**Rezoning Application:** PD 22-0648

**Development Services Department**

ZHM HEARING DATE: DECEMBER 12,2022
BOCC LUM MEETING DATE: FEBRUARY 7, 2023 CASE REVIEWER: SAM BALL

2.4 Proposed Site Plan (partial provided below for size and orientation purposes. See Section 8.0 for full site plan)

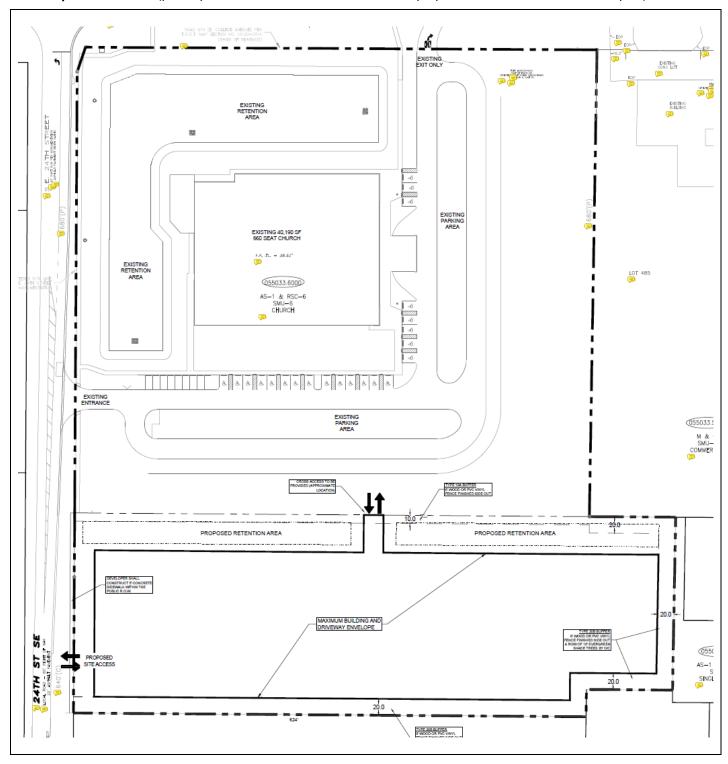
- The access connection to SE 24<sup>th</sup> St. does not meet minimum 245 feet spacing standards for a Class 6 roadway required by LDC, Section 6.04.07. A Section 6.04.02.B. Administrative Variance allowing a reduced standard will need to be recommended for approval by the County Engineer before the zoning can proceed to a hearing. Staff notes that the applicant submitted a request but failed to obtain a finding of approvability from the County Engineer by the time of this review.

- The project does not appear to meet the LDC, Sec. 6.04.03.I. requirement governing number of access
  connections. As such, A Section 6.04.02.B. Administrative Variance may be required; however, staff
  notes that until a sufficient transportation analysis has been submitted (as further described below) a final
  determination cannot be made.

- As SE 24th St. is a substandard roadway, the applicant is required to commit to improving the roadway to standard from the project entrance to the closest standard roadway segment or obtain a finding of approvability from the County Engineer for a Design Exception (DE) or Section 6.04.02.B. Administrative Variance (AV). This must be addressed before the zoning can proceed to a hearing. Staff notes that the applicant submitted a Section 6.04.02.B. Administrative Variance but failed to obtain the recommendation of approvability.

- The proposed right-in/right-out driveway connection to SE 24<sup>th</sup> St. utilizes a driveway channelization treatment or "pork chop" which does not appear to meet TD-17 standards as found within the TTM. The

revised site plan with the proposed "pork chop" was submitted passed the revised plan deadline and therefore did not allow staff sufficient time for adequate review if the proposed treatment will allow for safe and efficient operation of the access connection. Staff believes a Design Exception, recommended for approval by the County Engineer, will be required before the case can proceed forward with the proposed design. Alternatively, a 4-foot wide raised concrete separator is the preferred solution and would not require a Design Exception to implement.

- Please redesign to provide a 4-foot wide raised concrete separator at the right-in/right-out access connection on SE 24<sup>th</sup> St. The separator will also need to be with sufficient length to ensure vehicles do not try to circumvent the separator/turning restriction.

- The PD site plan shows access to SR 674/ College Ave., an FDOT facility. The applicant has not provided any documentation of official FDOT comments regarding the proposed access. Staff notes that the Hillsborough Corridor Preservation Plan identifies SR 674/College Ave, as a future 6-lane improvement. As previously notified by staff, the applicant must reach out to the FDOT Tampa Operations Permitting regarding whether an access will be approvable, as well as any site access improvements or right-of-way preservation which may be required.

- As required by Section 6.03.02 of the LDC, the US DOJ 2010 ADA Standards and Florida Accessibility
  Code, a minimum 5-foot wide accessible sidewalk is required to each building entrance and site arrival
  point, including between each use within the PD. The proposed detailed PD site plan does not
  demonstrate that said sidewalk connectivity will be provided. Please provide a sidewalk adjacent to the
  vehicular cross-access connections between the Church use and the Mini-warehouse use; and the subject
  property and the adjacent folio#55037.4000.

- The adjacent property to the south (folio# 55037.400) has a future land use designation for Suburban Mixed Use -6 allowing for commercial uses. As such, a vehicular and pedestrian cross access stubout to the adjacent property is required per Section 6.04.03.Q. The detailed PD site plan fails to show compliance with this requirement. Please revise site plan to clearly label/designate a vehicular and pedestrian cross access.

Given the above, the site plan does not adequately reflect the proposed improvements or address site access issues, the application is incomplete, and there was insufficient time for staff to review that such impacts could be approved as a result of the applicant submitting a revised site plan and addition materials after the revised plan deadline. As such, staff recommends denial of the application.
